TO: Khadeja Sarwar, Atwell, LLC
FROM: Cynthia Liston Thye, Planner I
DATE: 9/26/2025
SUBJECT: Parker Pointe, Black Rock Coffee, Site Plan
Review Comments 04

Description: Parker Pointe F1 AMD 1 L4A - Drive Through Coffee Shop	Status: REVISIONS REQD 3+
Type: SITE PLAN	Status Date: 9/10/2025
Subtype: SITE PLAN - NON RESIDENTIAL	Applied: 12/9/2024
Address: 13135 DECLAN DR	Approved:
City, State, Zip: PARKER, CO 80134	Closed:
Project Manager: Cynthia Liston Thye	Expired:
Details: The applicant, Black Rock Coffee, is proposing a Site Plan for a coffee shop with a drive through. The site is located southeast of the intersection of Parker Road and Stroh Road.

DRAWN BY: K. SARWAR
 CHECKED BY: N. SALAZAR
 PROJECT MANAGER: N. SALAZAR
 JOB #: 24003198
 FILE CODE: ##
 SHEET NO. C2.00

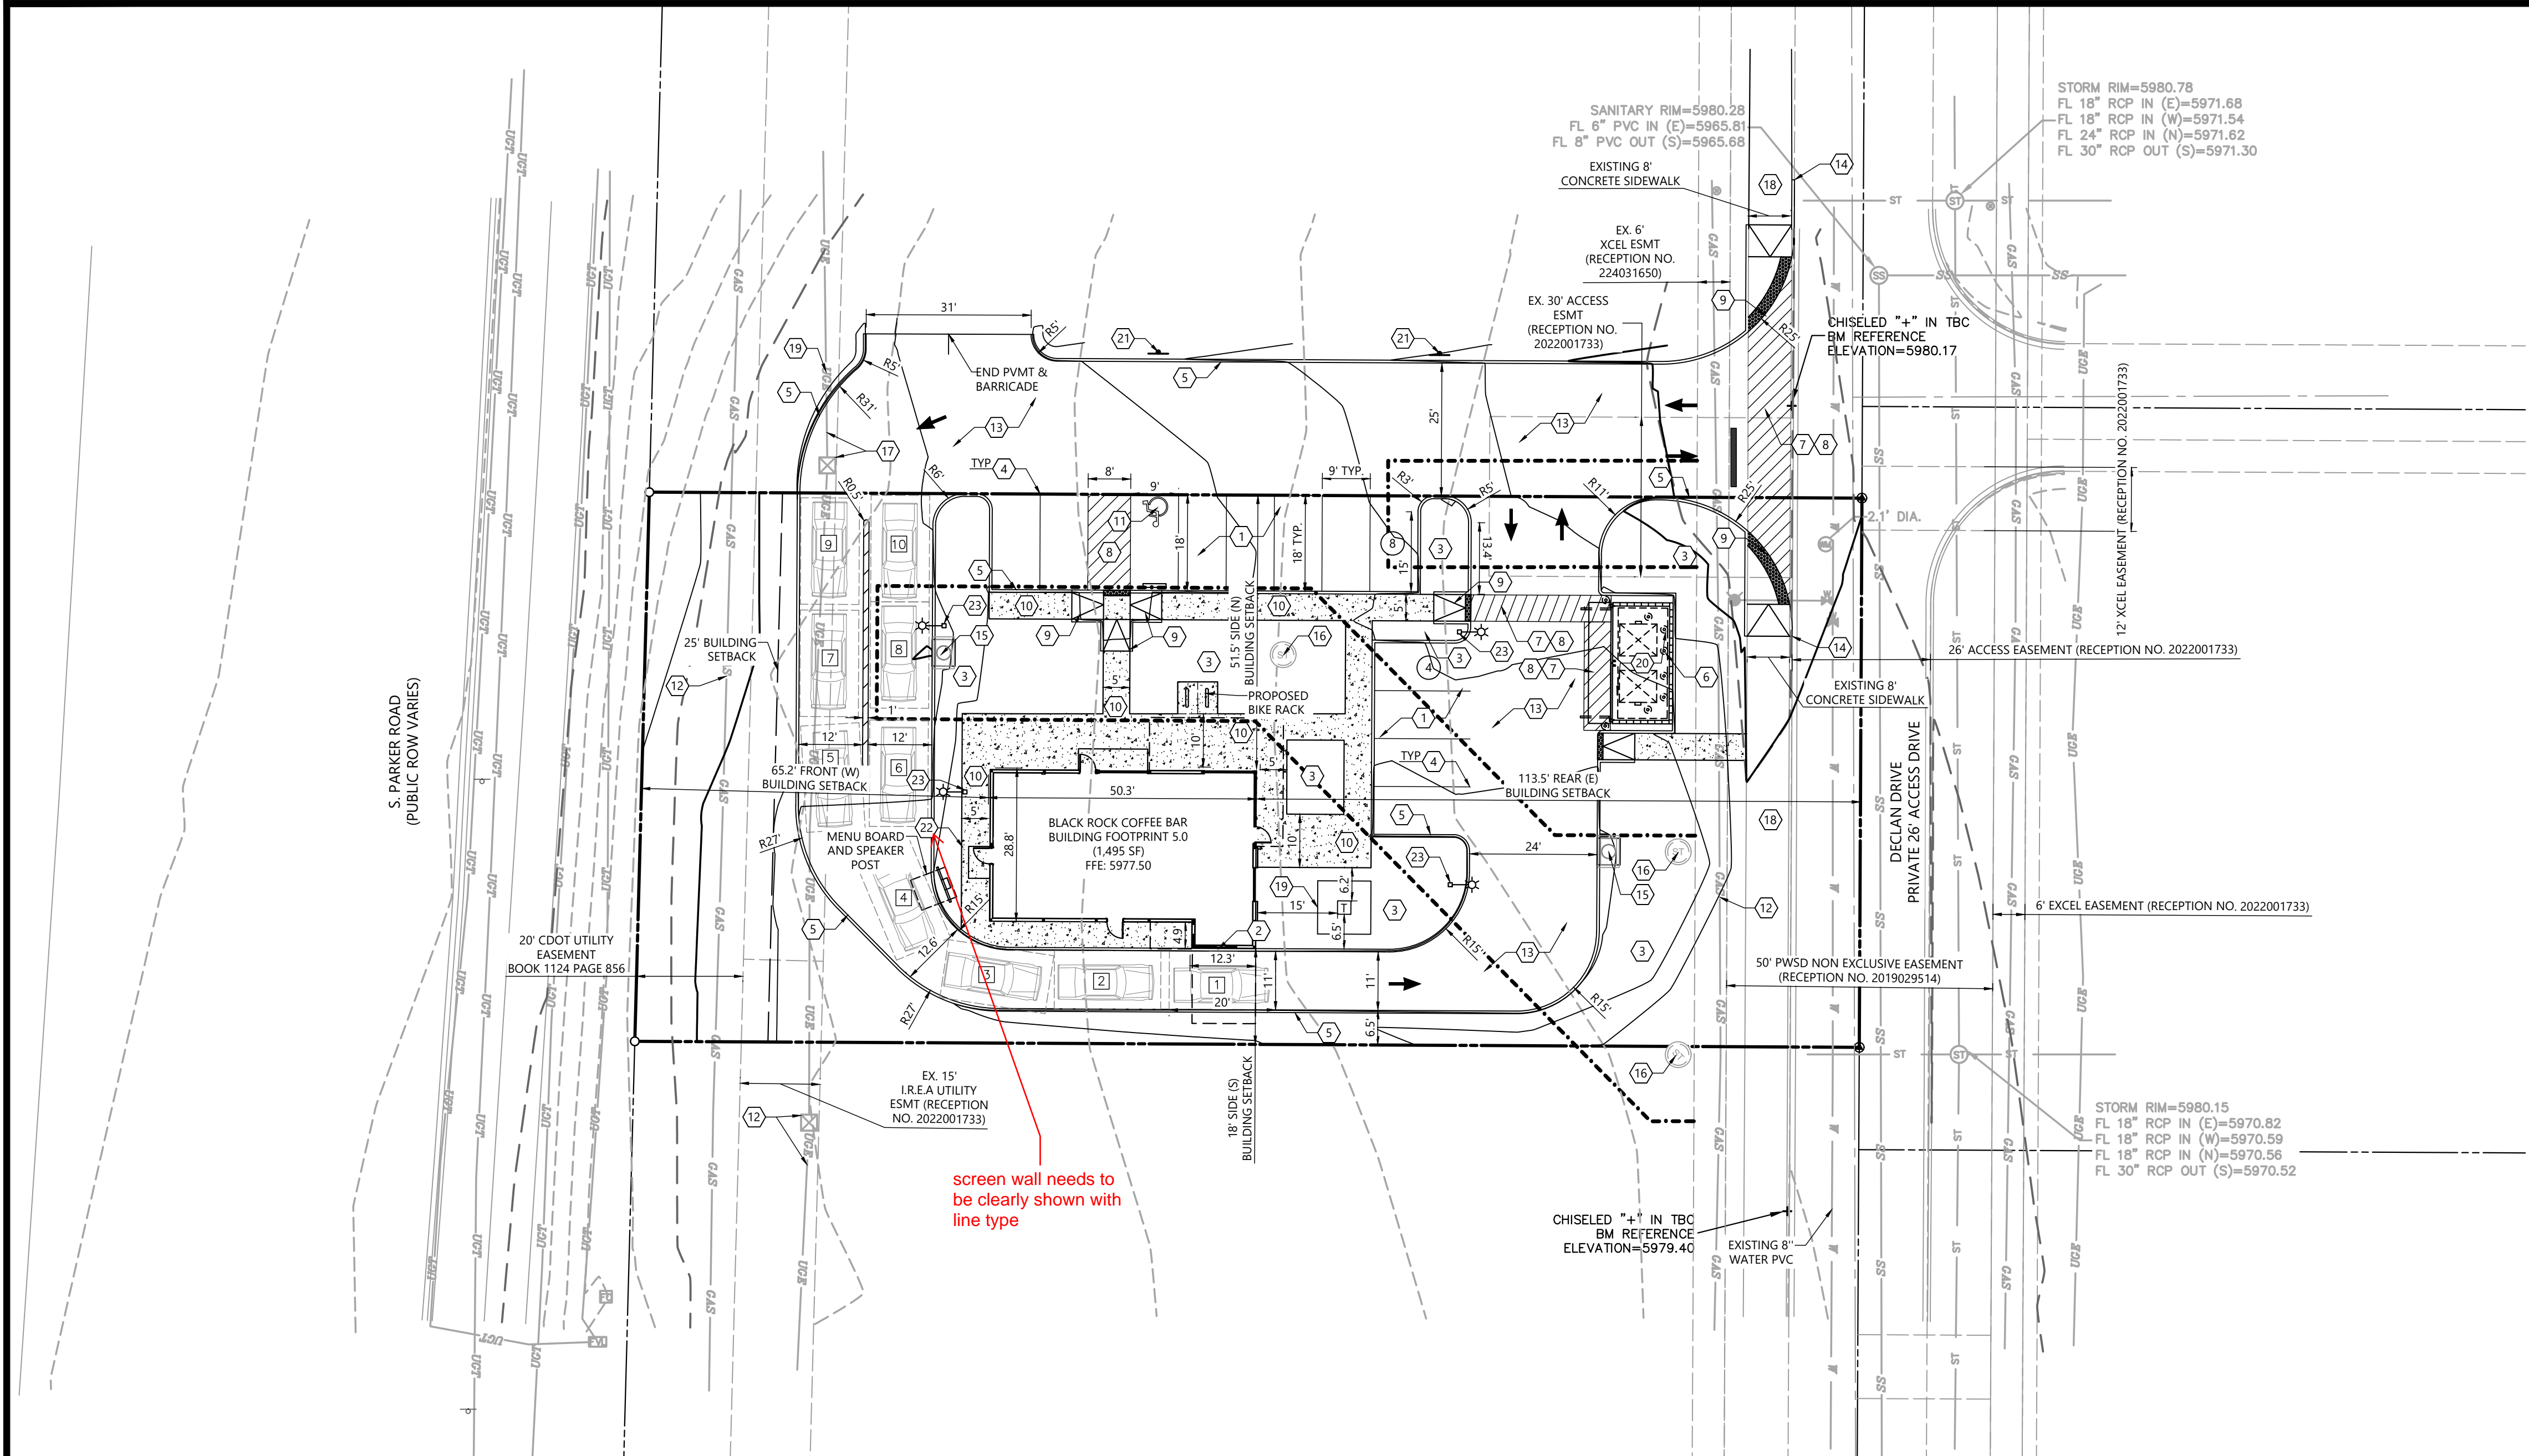
screen wall needs to be clearly shown with line type

DRAWN BY: AD
 CHECKED BY: PC
 PROJECT MANAGER: AV
 JOB #: 24003198
 FILE CODE: ##
 SHEET NO. E.1.1

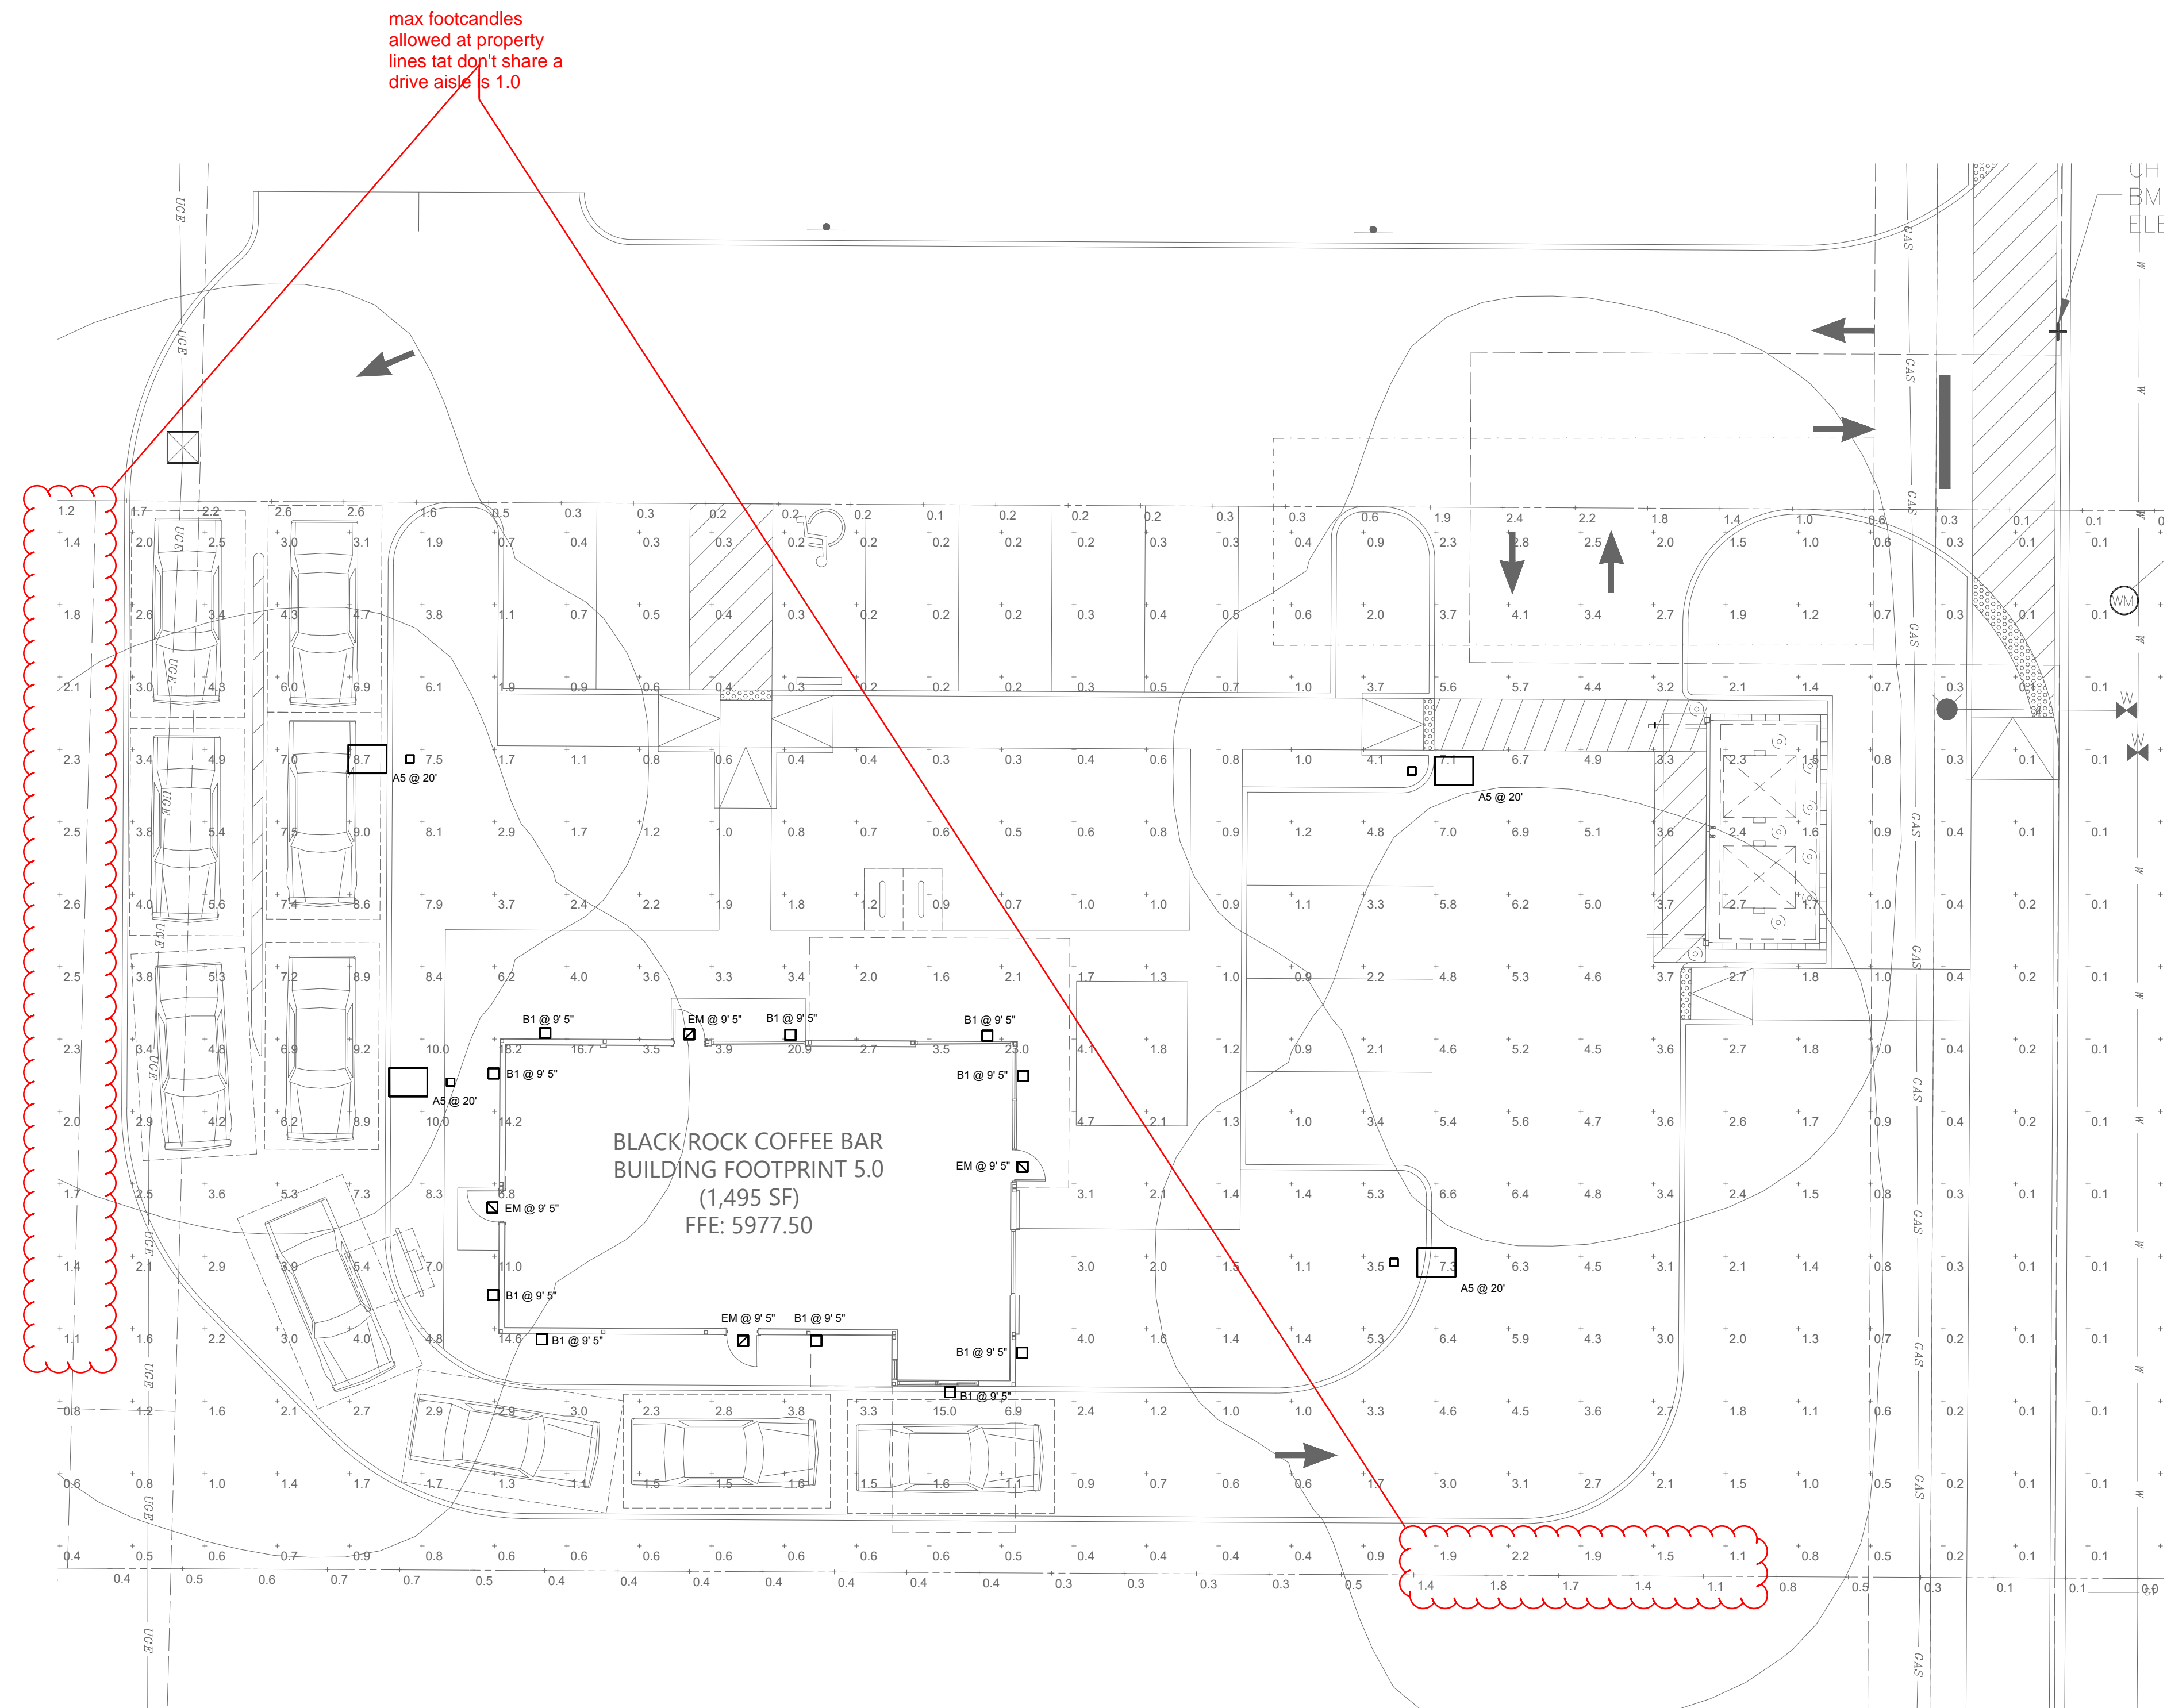
max footcandles allowed at property lines that don't share a drive aisle is 1.0
